From: Dourte, Richard H.  
Sent: Tuesday, September 28, 2010 9:44 AM  
To: Cherne, Curtis ; Sims, Timothy E.  
Cc: 'chuck@energy-associates.com'  
Subject: (12808 Piru SE)

*Drainage Report  
for*

*Tijeras Heights  
Subdivison*

RE: Tijeras Heights

## TYPICAL LOT DRAINAGE

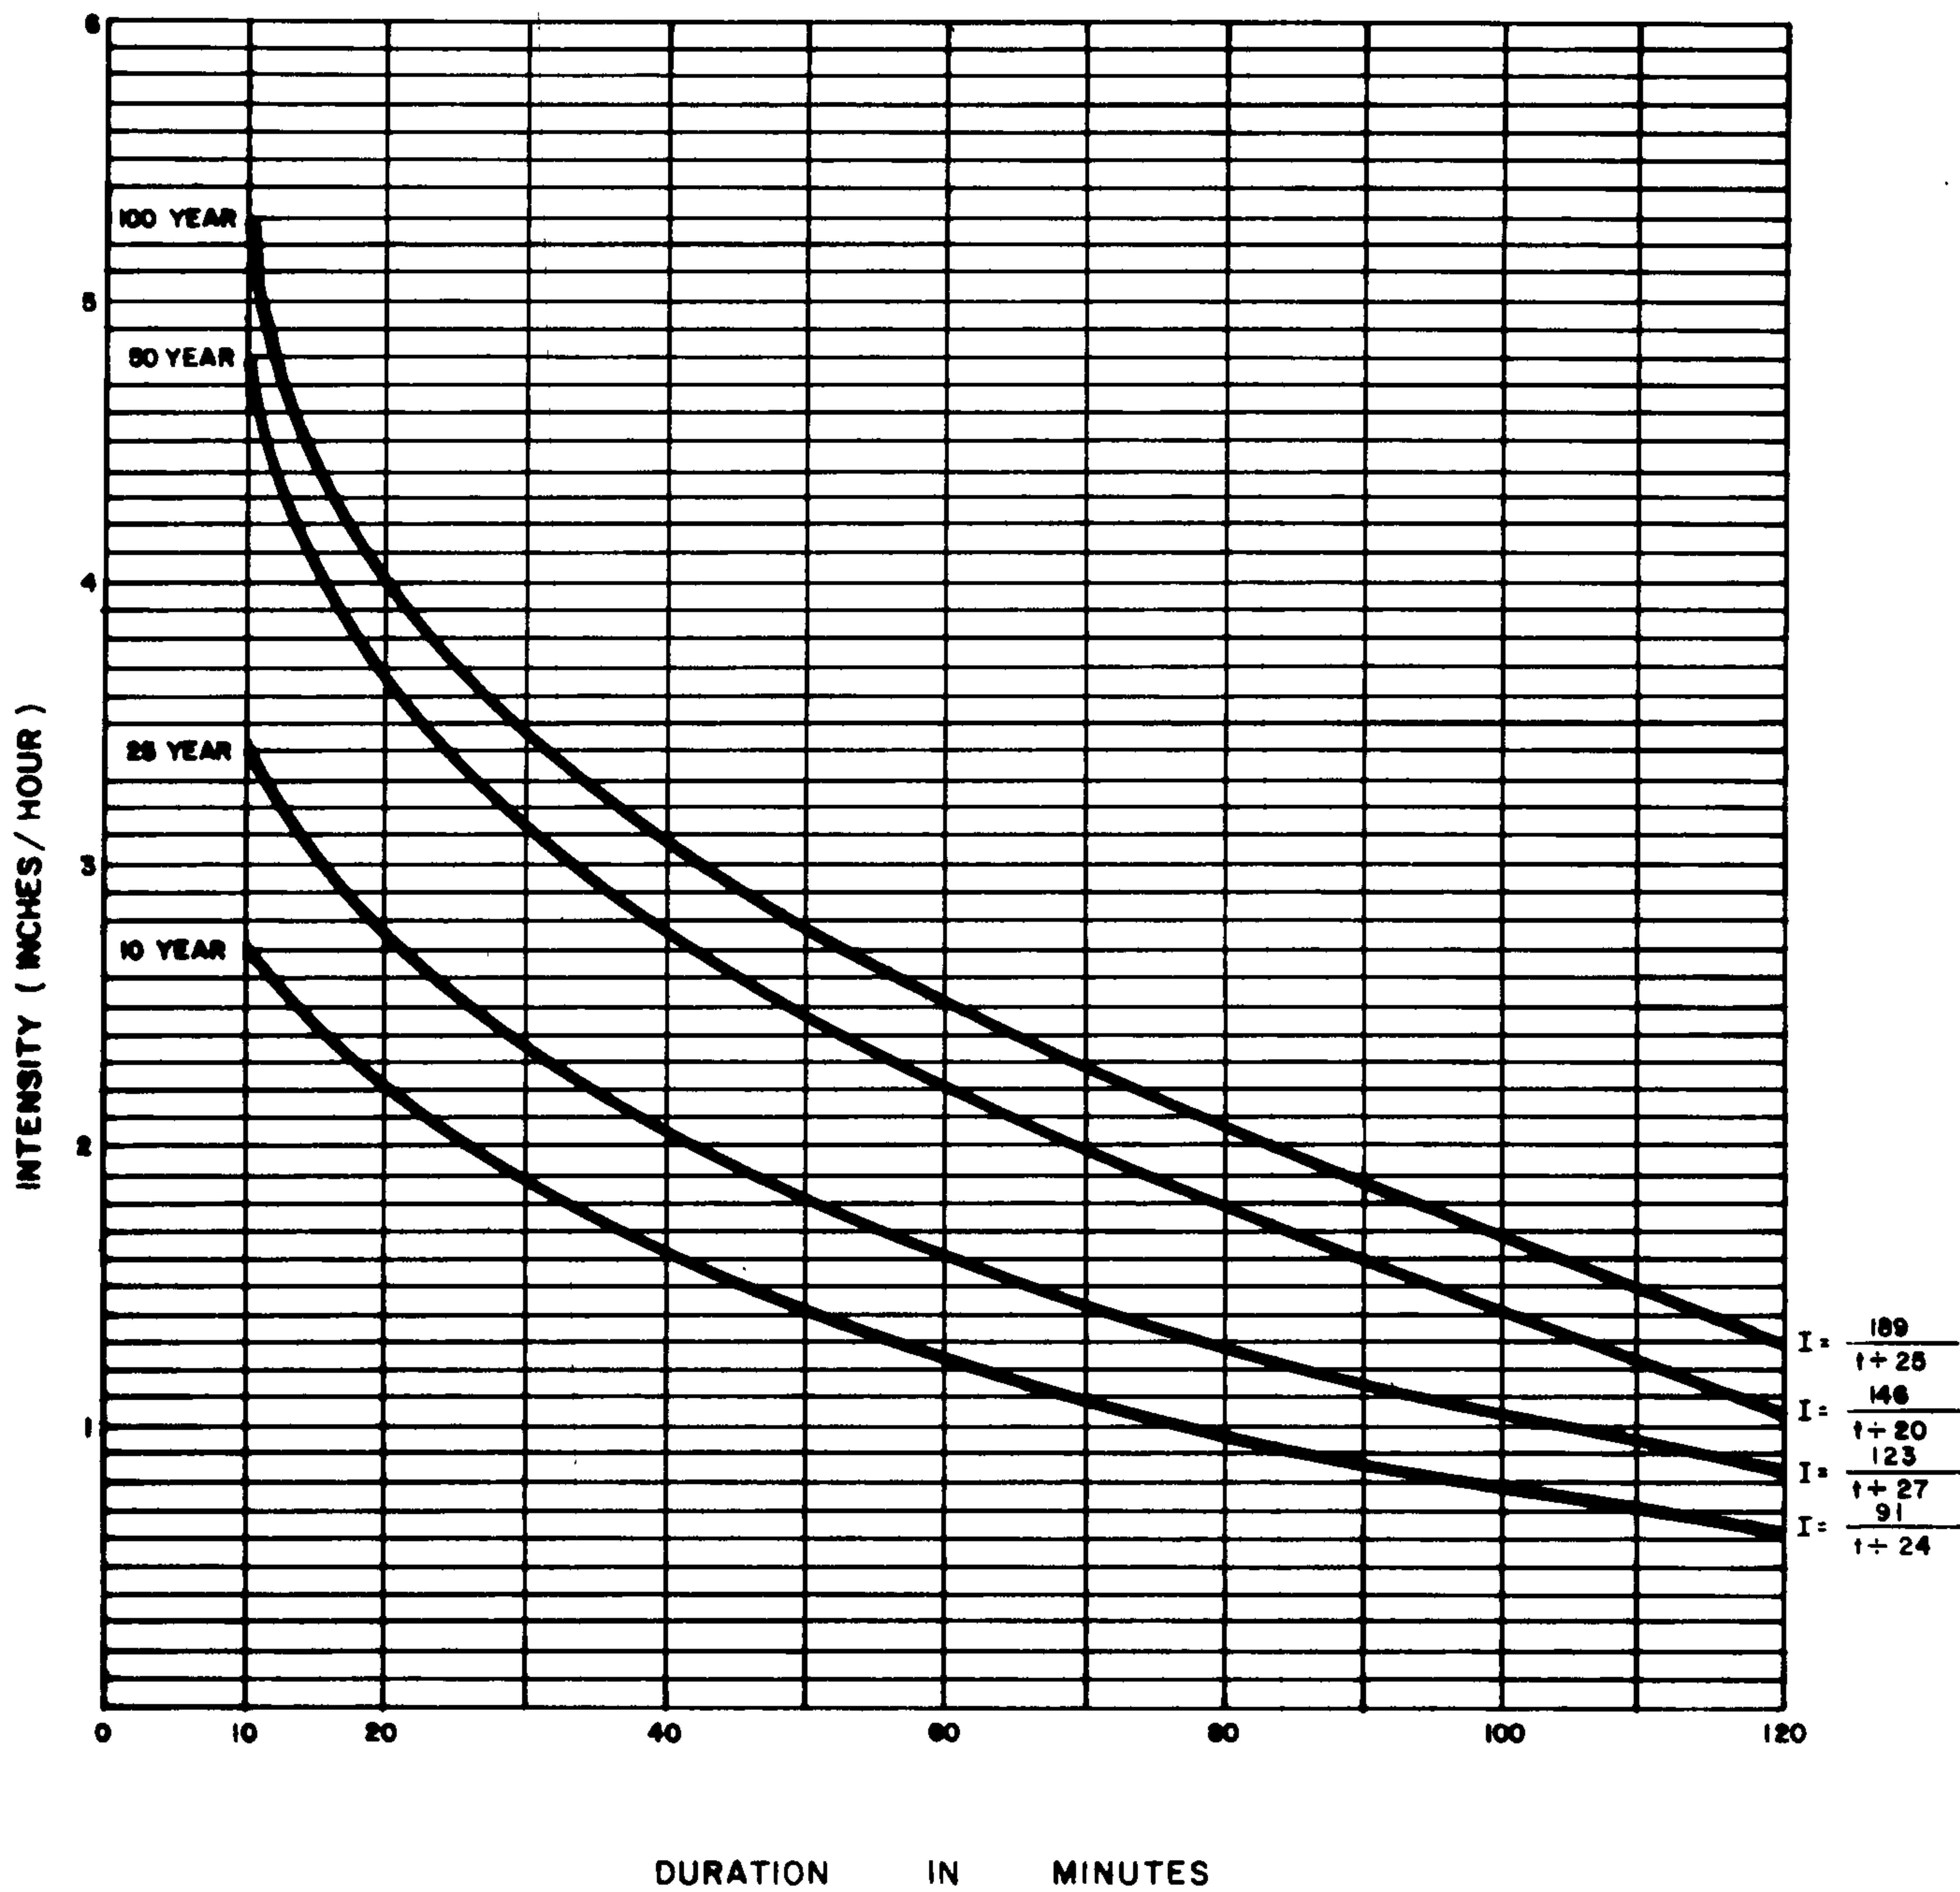
The drainage provision for Tijeras Heights Subdivision are generally acceptable except for the recommendation of allowing the runoff from the rear lots to flow over the embankment and directly into the Tijeras Arroyo. The discharge of the runoff into the Arroyo is not objectionable in itself, rather the possibility of gullying and erosion of the steep bank. For instance as shown on Figure 4 of the drainage report Lots 1,2,5,6 & 18 appear to be particularly susceptible to damages. I would therefore like to receive an addendum indicating a positive method of control of the potential erosion problem.

1. A note will be placed on the final plat stating - "All front yards and roofs shall drain to Piru Blvd. and drainage from rear yards shall not form a concentrated discharge but shall remain as sheet flow when draining to the arroyo".
2. The developer will not dedicate the flood plain to AMAFCA at this time.
3. The developer intends to retain the bank of the arroyo as open space.
4. AMAFCA concurs with the drainage plan as submitted and modified herein.
